Central Precinct Renewal Program

Response to Submissions Addendum
– Social Infrastructure and Health
Impact Assessment

August 2023

Figure 2: Revised Urban Design Framework

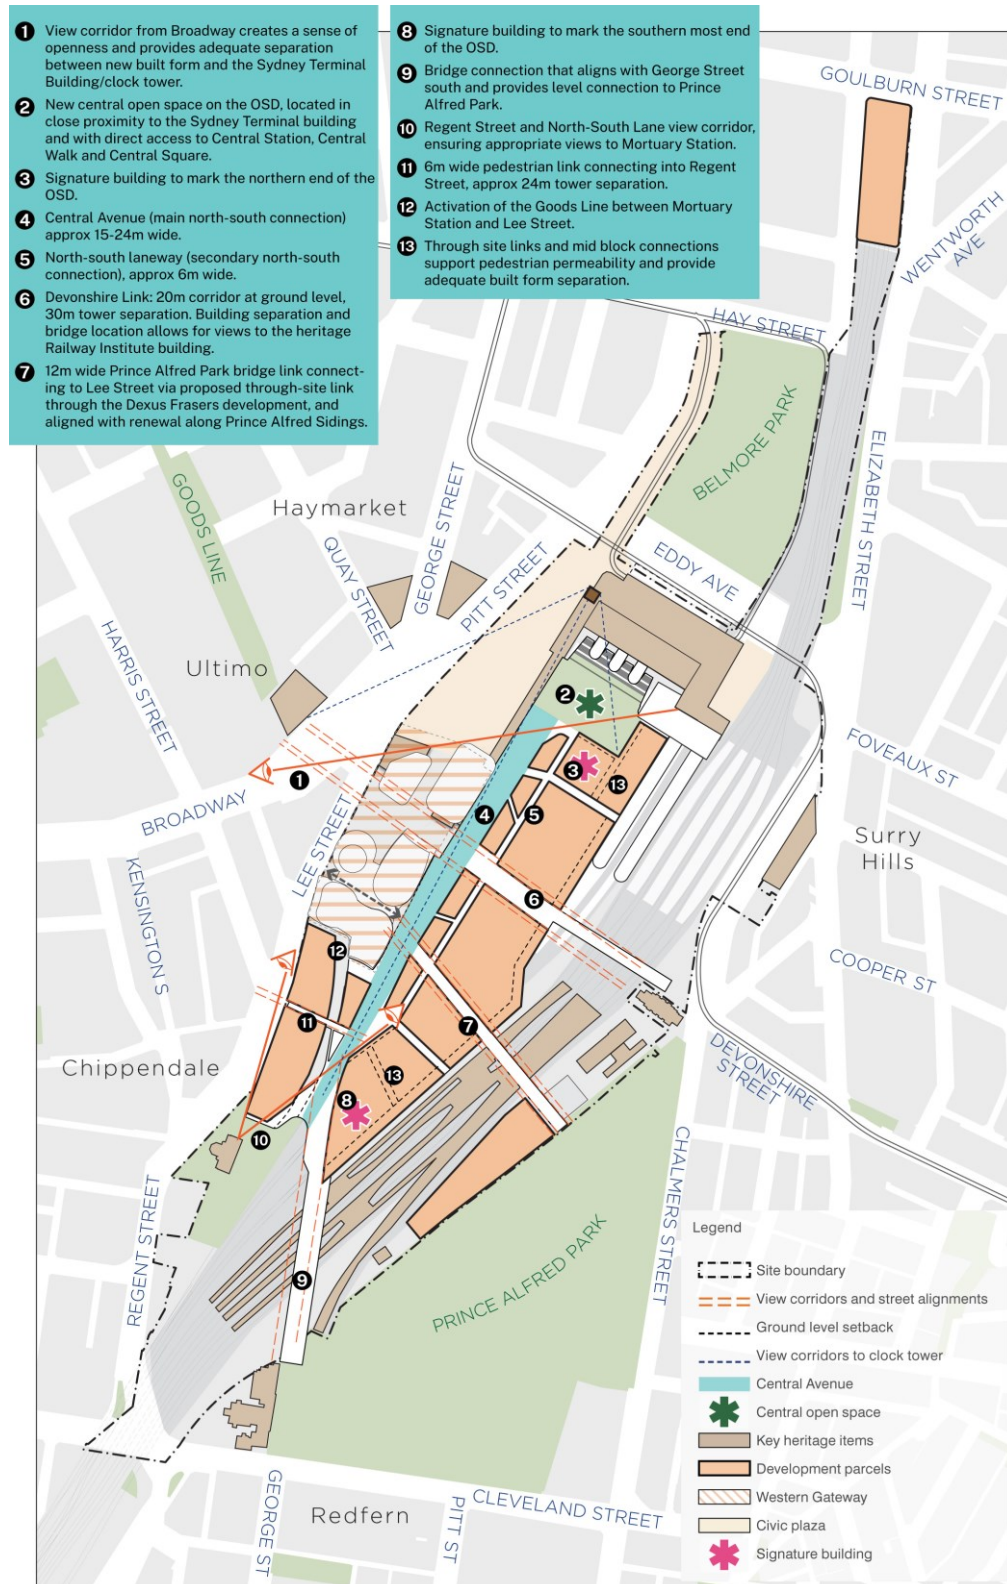
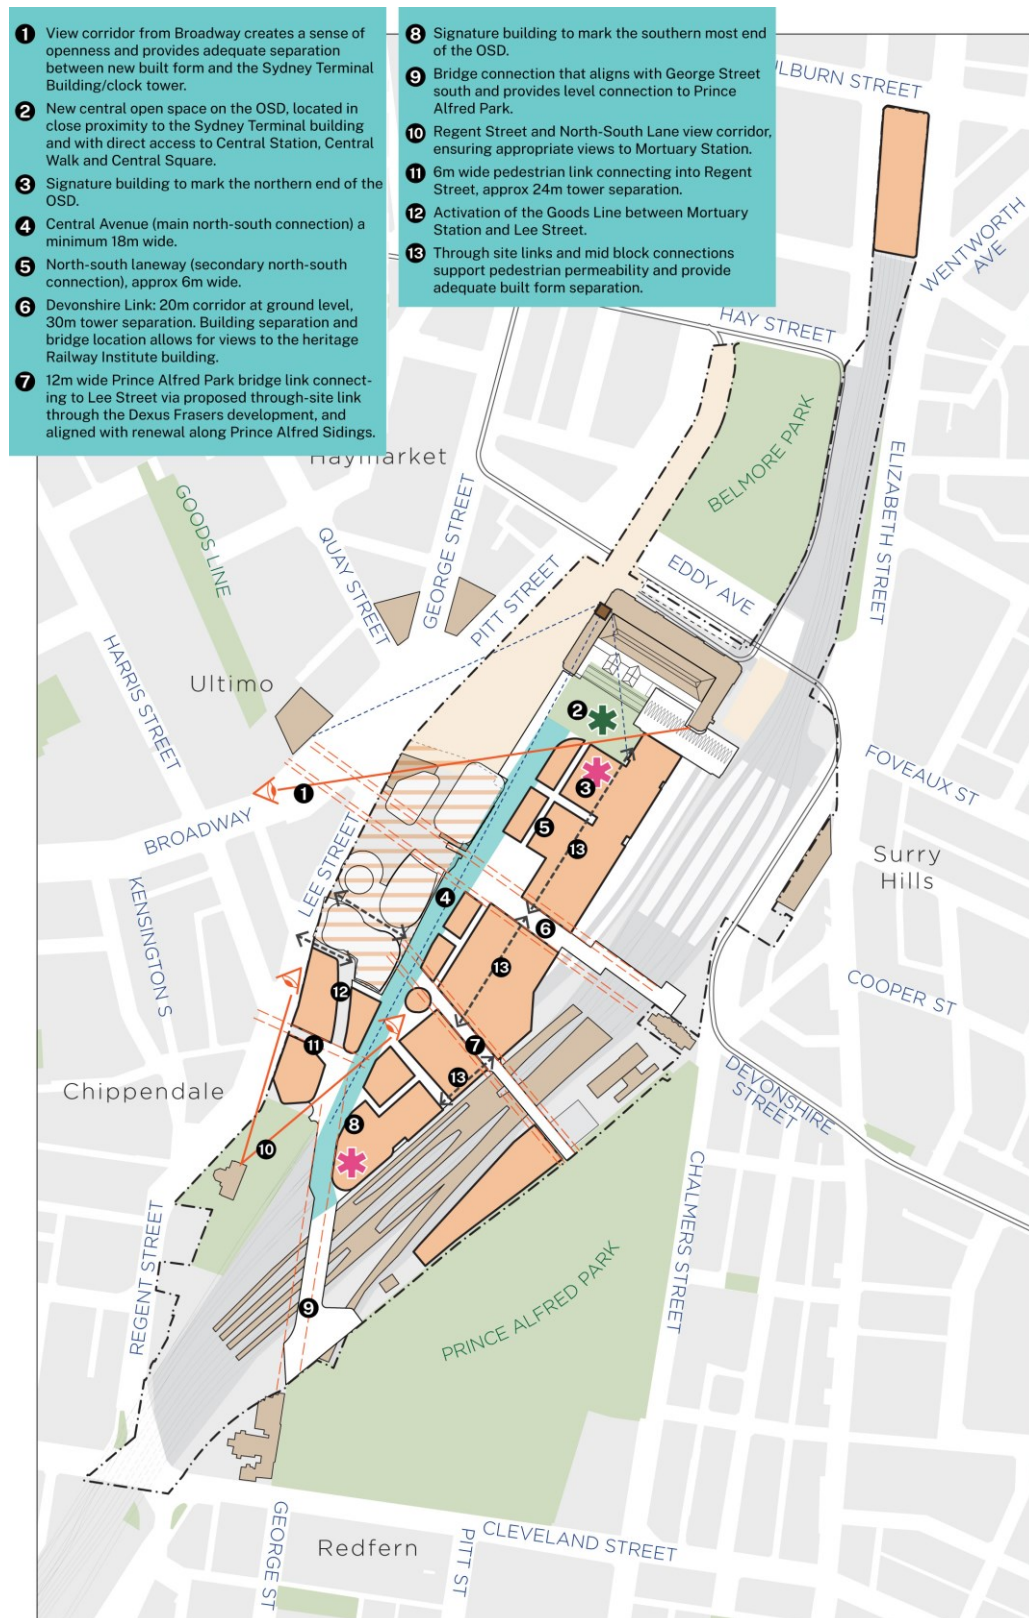
The feedback on the exhibited rezoning proposal has informed subsequent amendments to the Reference Masterplan. A summary of the key changes adopted as part of the revised Reference Masterplan are described below:

- **Improved interface between Terminal and OSD:** The interface relationship between the OSD deck and the Terminal Building has been further rationalised to improve the function of the station as a major interchange and better respect the heritage of Central Railway Station. The following changes have been made:

- a reduced spatial extent of the stairs between the OSD deck and the Terminal to now be a consolidated vertical connection (stairs, lift and escalators) to the north-eastern edge of Central Green

- an expanded concourse level with greater access to daylight and new opportunities for landscaping that will improve the passenger experience on the platforms and in the concourse, compared to the exhibited proposal

- incorporating an interpretation of the platform canopies to deliver a heritage-responsive and weather-protected connection.
- **Consistent 18-metre-wide Central Avenue:** A consistent width of 18 metres has been provided for Central Avenue. The future role and function of this link has been revised from an avenue between the north and south of the OSD deck to now becoming a connector of a sequence of public spaces on the OSD deck.

- **Additional mid-block through-site links:** The introduction of additional mid-block connections to reinforce breaking up the podiums on the OSD deck level into interconnected smaller building forms.

- **Removal of the Eastern Colonnade:** The eastern colonnade has been removed from the revised Reference Masterplan.
- **Reconfiguration of Central Green:** The layout of Central Green has been adjusted to be a squarer geometry compared to the exhibited proposal. The primary movement path through Central Green is now focused toward the southern and eastern edges of this open space. The indicative design of Central Green has also been adjusted to improve its relationship with the Terminal Building through the incorporation of seating and greater landscaping at the northern edge of the park.

- **An enlarged Mortuary Station Plaza:** The reduction of the podium building envelope of the Regent Street Sidings building brought about through changes to the bus layover and basement entry /exit pathways provide for an enlarged public space at Mortuary Station Plaza by 2,030 square metres to a total area of 6,500 square metres. The increase in the size of this public space also presents the opportunity to retain the existing fig tree at Mortuary Station and provide a new playground that is accessible to the broader community.

- **Devonshire Square:** A new square of approximately 3,700 square metres has been included into the revised Reference masterplan at the junction of Central Avenue and the Devonshire link, which will provide a new civic space at the entry point to the proposed extended Central Walk. (Central Walk will provide access to all of the rail platforms in Central).

- **Southern Plaza:** A new reconfigured civic space of approximately 4,700 square metres at the southern end of Central Avenue, providing a new arrival and meeting space when coming from the south. Within the Southern Plaza, there is the potential for a marker building that is designed with a Connecting with Country focus.

- **Regent Street Sidings:** The podium envelope at Regent Street Sidings has been further rationalised to improve the integration between the OSD deck level and Regent Street

Sidings, the Goods Line and Mortuary Station Plaza. This has been through the following changes:

- undergrounding the bus layover into the basement to enable the reduction of the podium footprint
 - consolidating basement entry/exit into a single location for loading, residential parking and bus layover

- locating basement entry/exit at a signalised intersection
 - increase the opportunity to activate the Goods Line and Mortuary Station Plaza
 - extending the OSD deck level to integrate with the podium rooftop of Regent Street Sidings.

- **Increased green cover:** An increase to the overall green cover in the precinct has been adopted as part of the revised Reference Masterplan.
 - **Enhanced east-west view lines:** The indicative building envelopes on the OSD deck have been refined in location and shape to increase the separation of tower forms and enhance east-west view lines.

- **Reduction in overall GFA:** Based on refinements to the Reference Masterplan, the overall proposed GFA of Central Precinct has reduced by approximately 10,600 square metres.
